MINOR AMENDMENTS TO FENESTRATION

<small>DO NOT SCALE THIS DRAWING WRITTEN DIMENSIONS ONLY TO BE USED ALL DIMENSIONS ARE IN MILLIMETRES ALL DIMENSIONS TO BE VERIFIED ON SITE ANY INCONSISTENCIES TO BE REPORTED TO THE ARCHITECT IMMEDIATELY</small>	Job No 7155 FOR CONSTRUCTION	p-ad 192D Campden Hill Road, Notting Hill Gate, London, W8 7TH <small>t: 0208-4590172 e: info@p-ad.com</small>		
	87-93 Kingsgate Road, London, NW6 4LA	Title TYPICAL WINDOW DETAILS		Number 7155/ 2.3
	Drawn by SG	Scale 1:20 @ A3

DO NOT SCALE THIS DRAWING WRITTEN DIMENSIONS ONLY TO BE USED ALL DIMENSIONS ARE IN MILLIMETRES ALL DIMENSIONS TO BE VERIFIED ON SITE ANY INCONSISTENCIES TO BE REPORTED TO THE ARCHITECT IMMEDIATELY	Job No 7155	p-ad 192D Campden Hill Road, Notting Hill Gate, London, W8 7TH t: 0208 4590172 e: info@p-ad.co.uk	
	FOR CONSTRUCTION		
	87-93 Kingsgate Road, London, NW6 4LA	Title Scale Drawn by SG	TYPICAL WINDOW DETAILS Number 7155/ 2.4

DETAIL
SCALE 1:20 @ A3

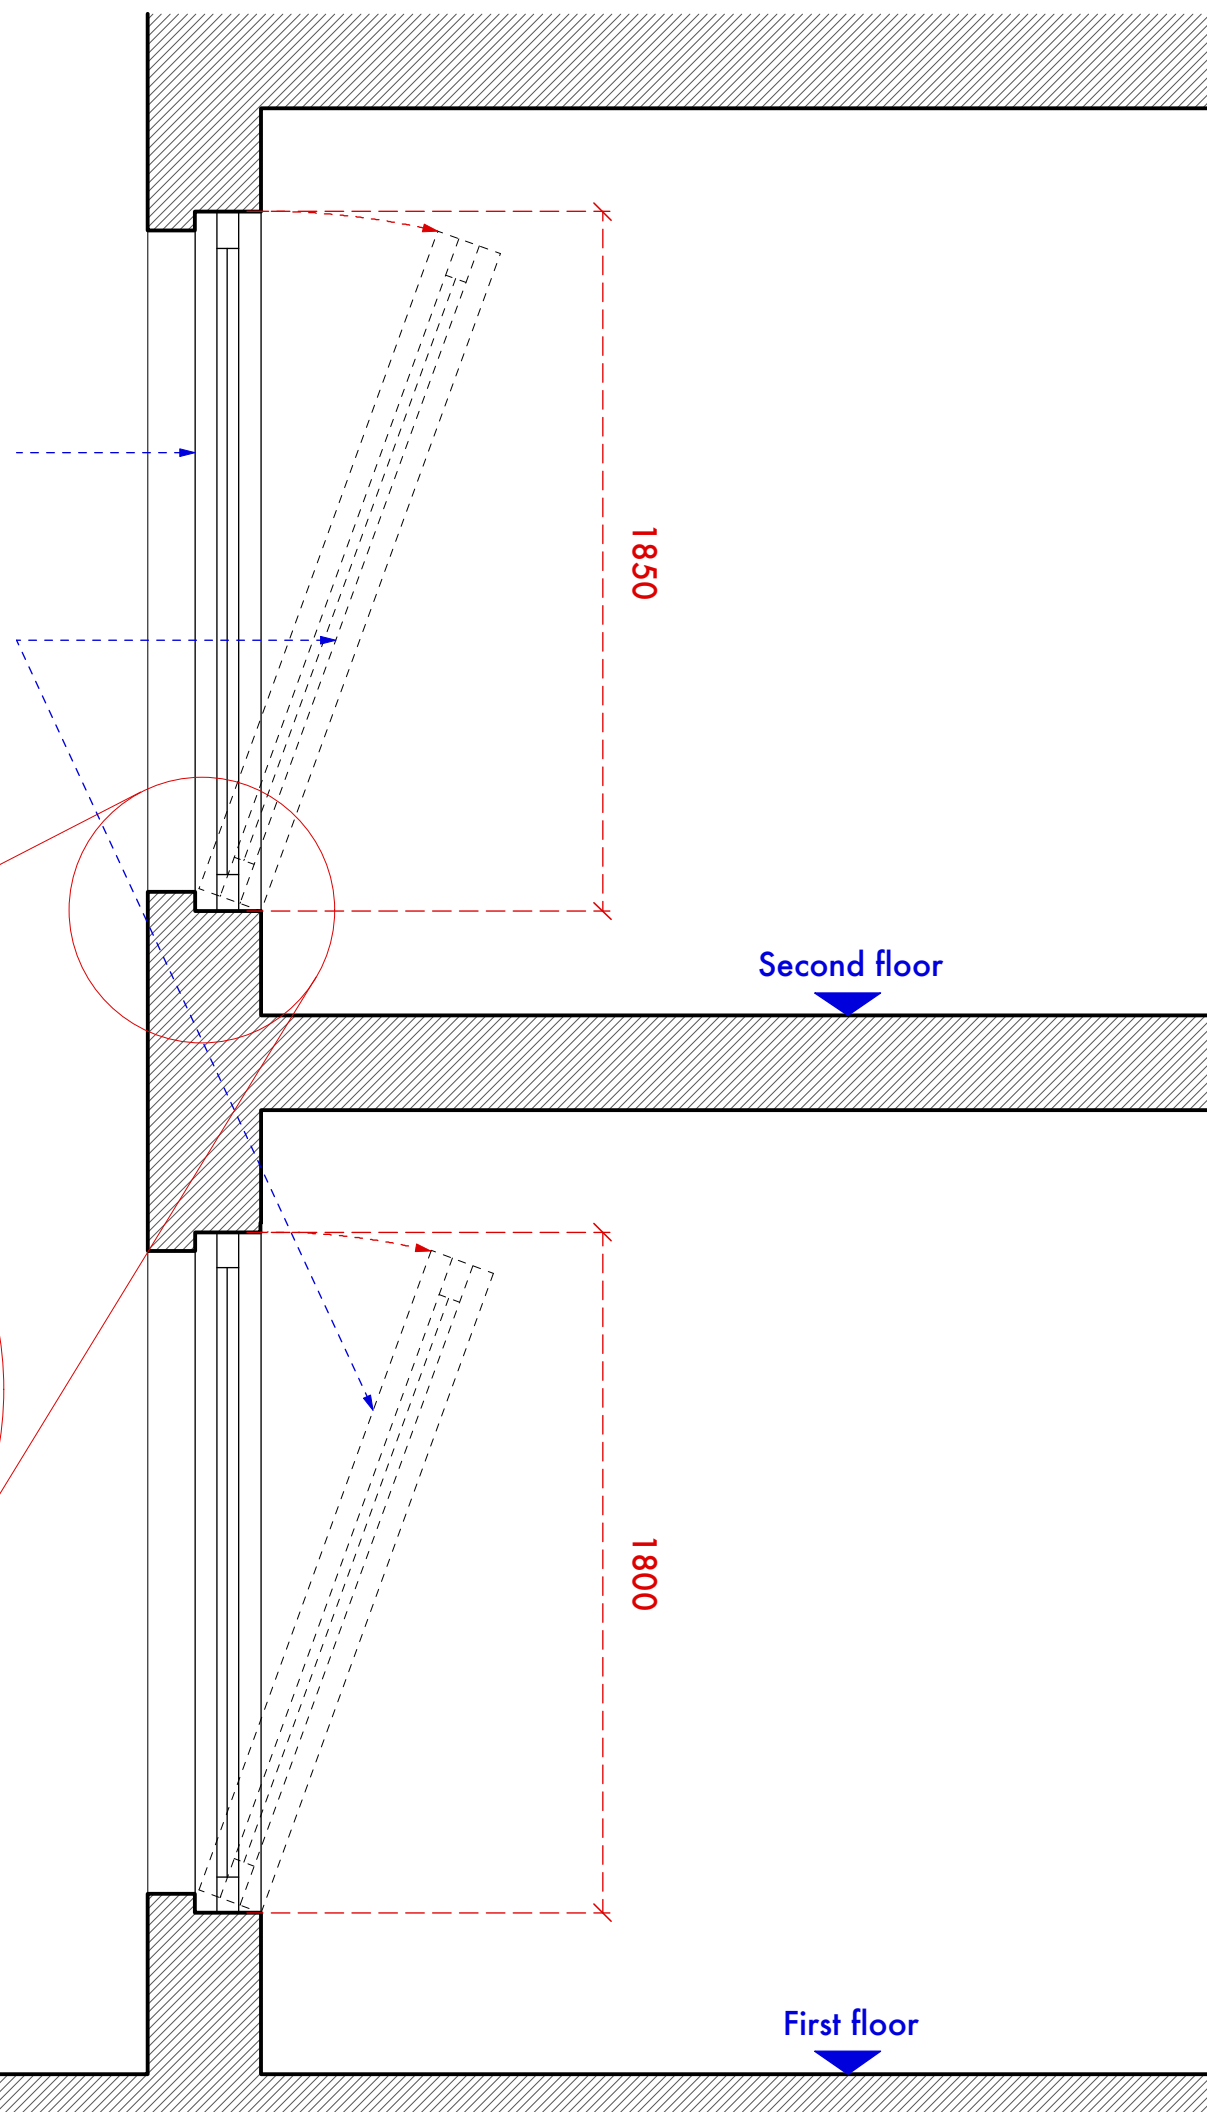
Windows recessed in opening as per previously approved drawings.

Proposed opening lights will be side hinged and also tilting as this allows good ventilation esp at night whilst maintaining security.

Elevation to show amended fenestration

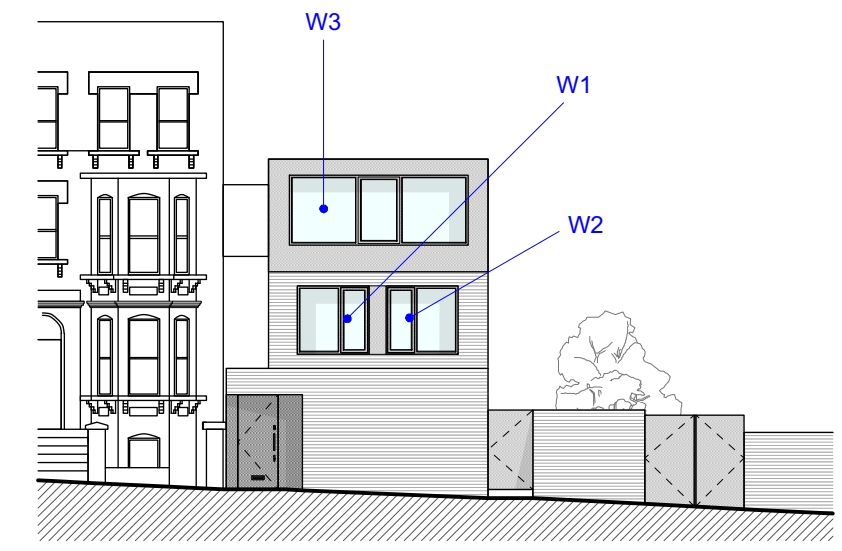
It proved impossible to find a manufacturer for the previous design of windows where the entire window was a single opening light. It was also advised that such a window would not achieve the required ventilation in the bedrooms and would not meet the U-Value requirements.

As such minor amendments to the fenestration are proposed to achieve both the ventilation requirement and thermal performance.

An openable light is introduced into each window. It would be both hinged and tilt opening to achieve good ventilation and has been designed to balance the elevation - see below and drawing 7155-05 Rev B.

Elevation to show amended fenestration

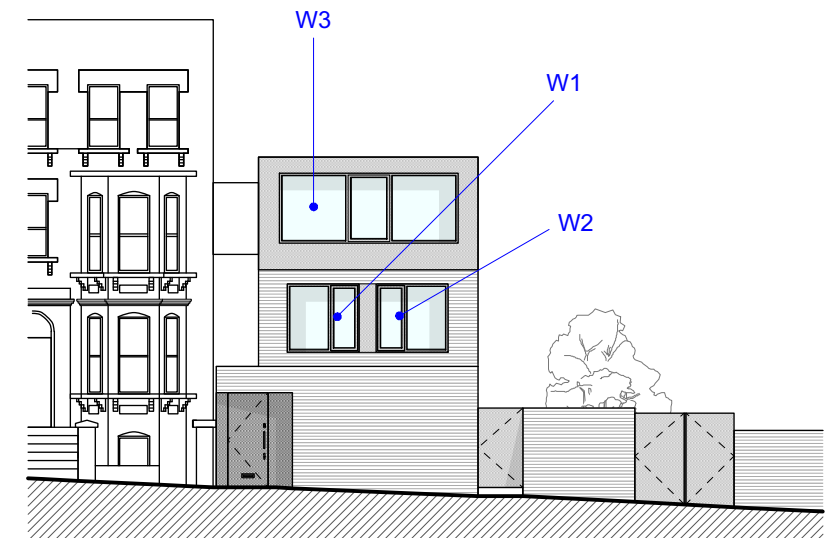
It proved impossible to find a manufacturer for the previous design of windows where the entire window was a single opening light. It was also advised that such a window would not achieve the required ventilation in the bedrooms and would not meet the U-Value requirements.

As such minor amendments to the fenestration are proposed to achieve both the ventilation requirement and thermal performance.

An openable light is introduced into each window. It would be both hinged and tilt opening to achieve good ventilation and has been designed to balance the elevation - see below and drawing 7155-05 Rev B.
